XLamp® XQ-A LED Product Change Notification

PCN Reference Number: CreeLED-PCN-5263

Date Issued: March 2, 2022

Please be advised that Cree LED is making improvements to the performance and physical characteristics of XLamp® XQ-A White, Blue, PC Blue, Green, PC Amber LEDs.

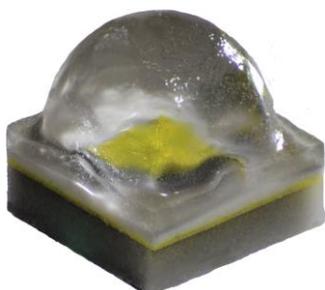
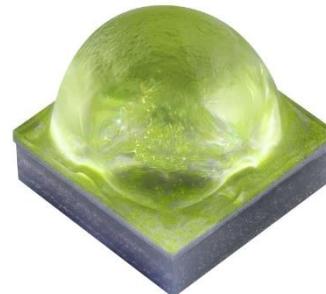
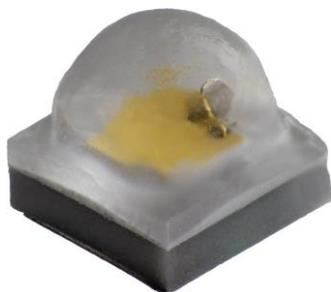
The visual appearance of the XQ-A LEDs will change. Examples of the current and new visual appearances are shown below.

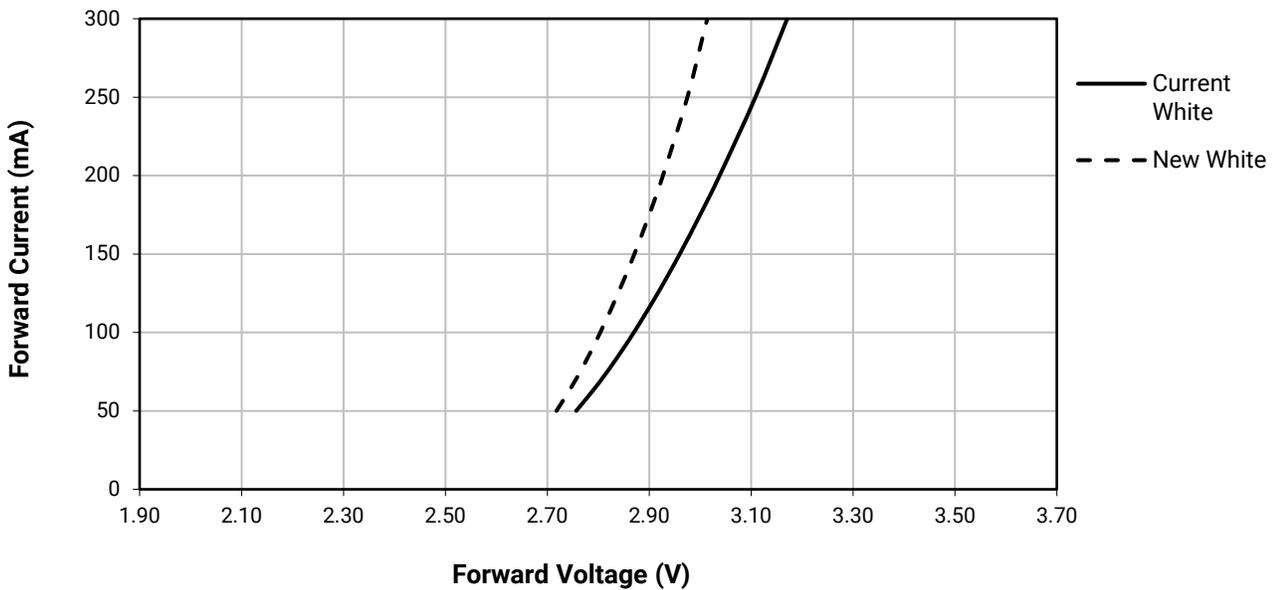
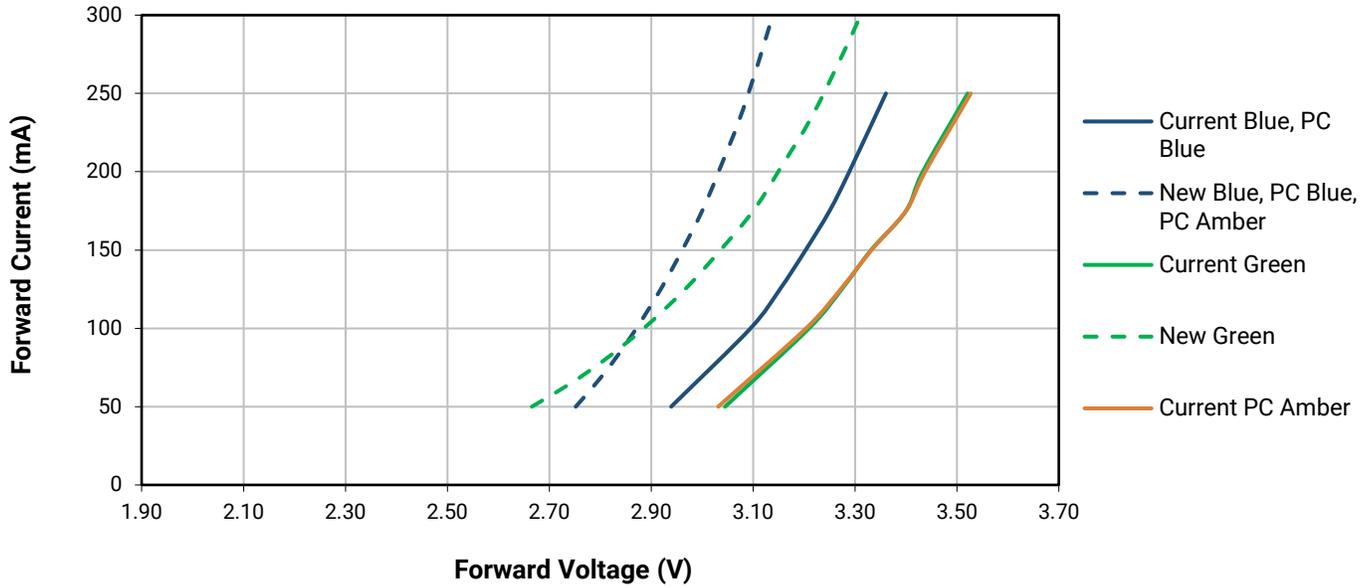
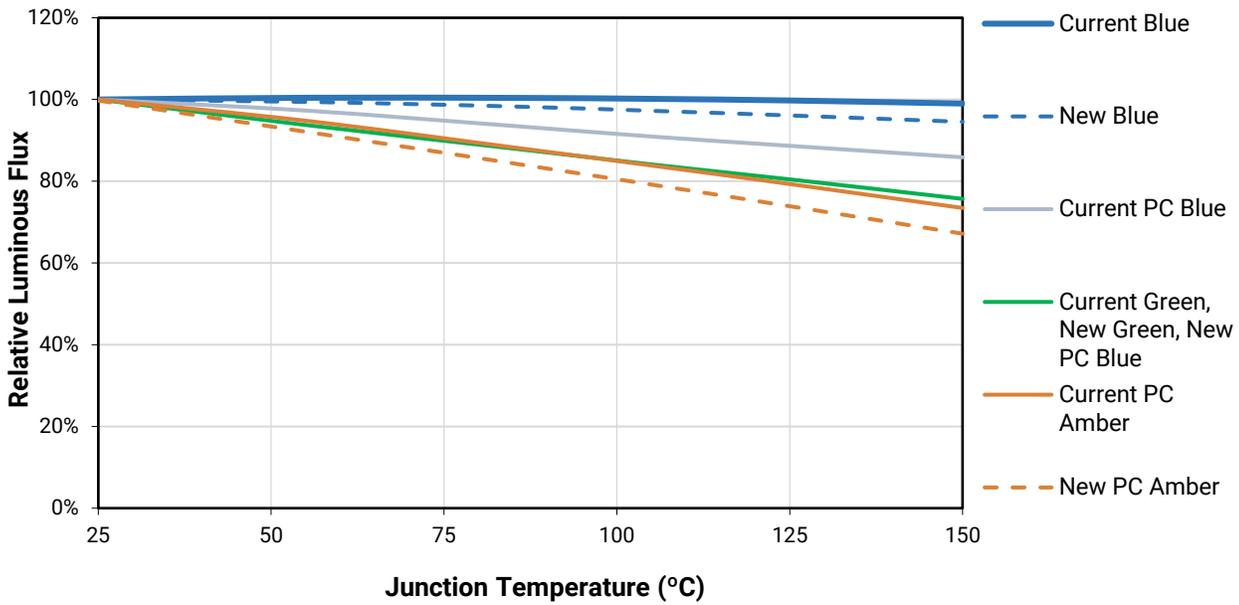
The following graphs show the improved Forward Voltage vs. Current curves ($T_j = 85^\circ\text{C}$).

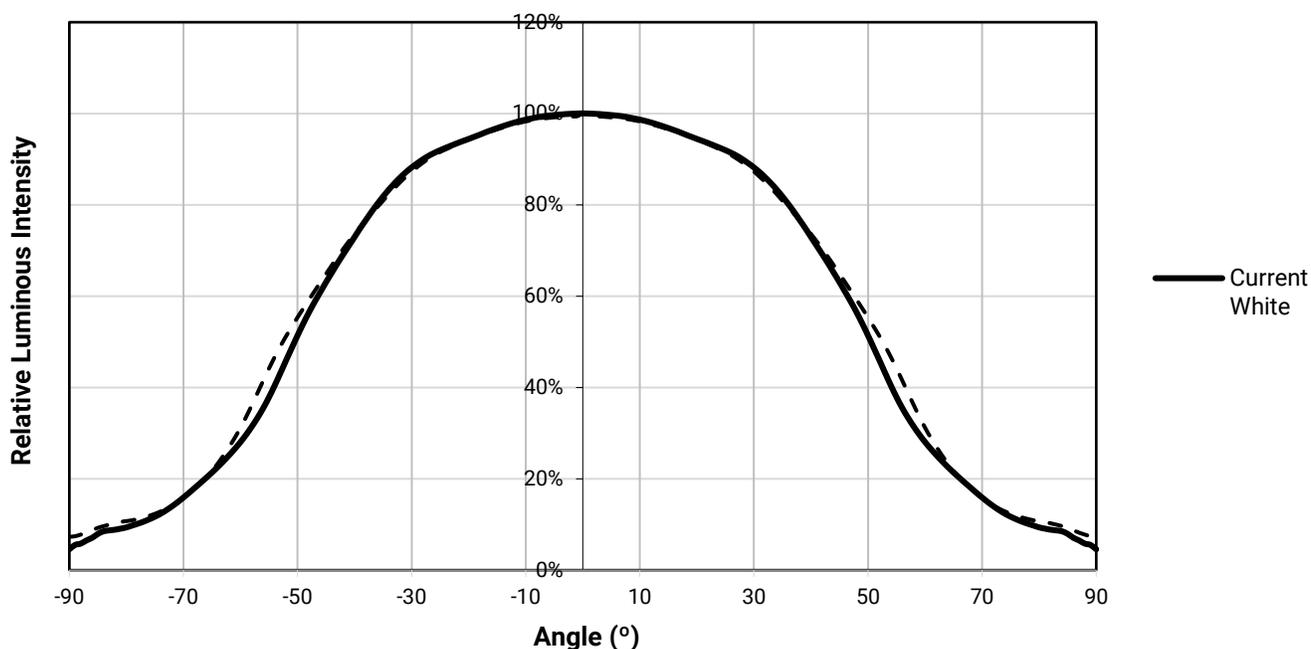
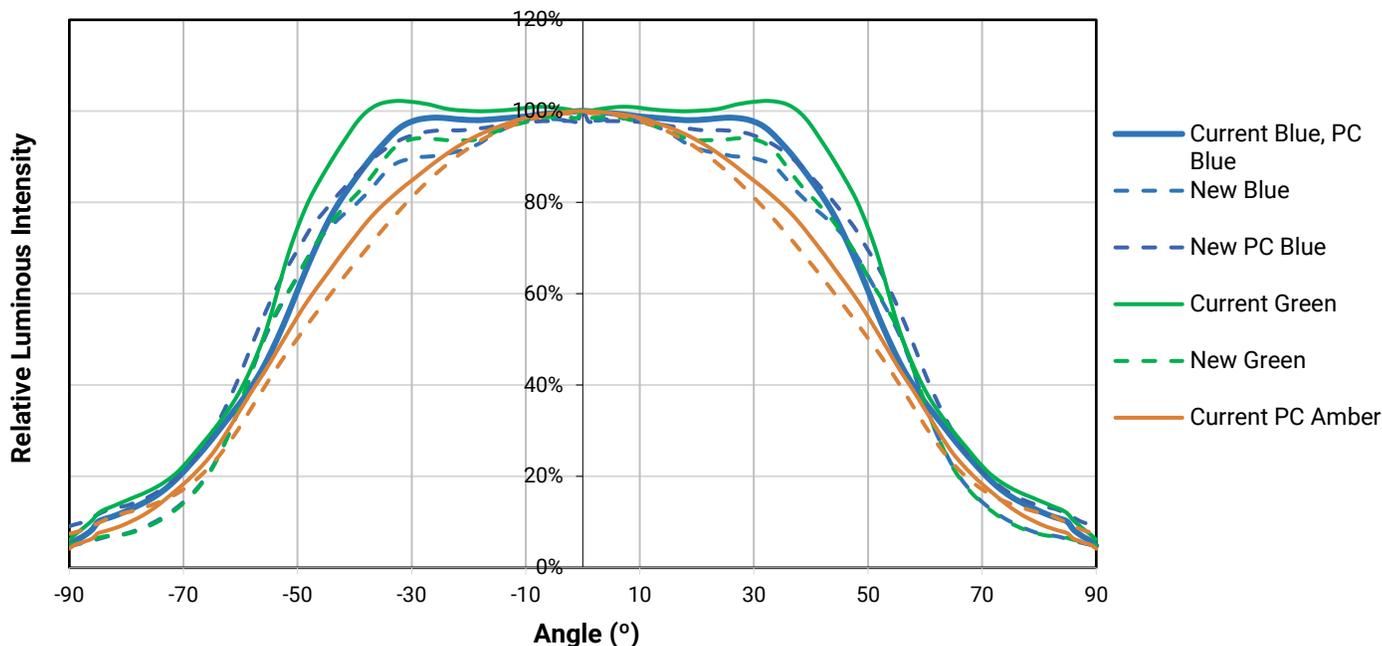
Far field comparisons between the current and new XQ-A LEDs are shown below.
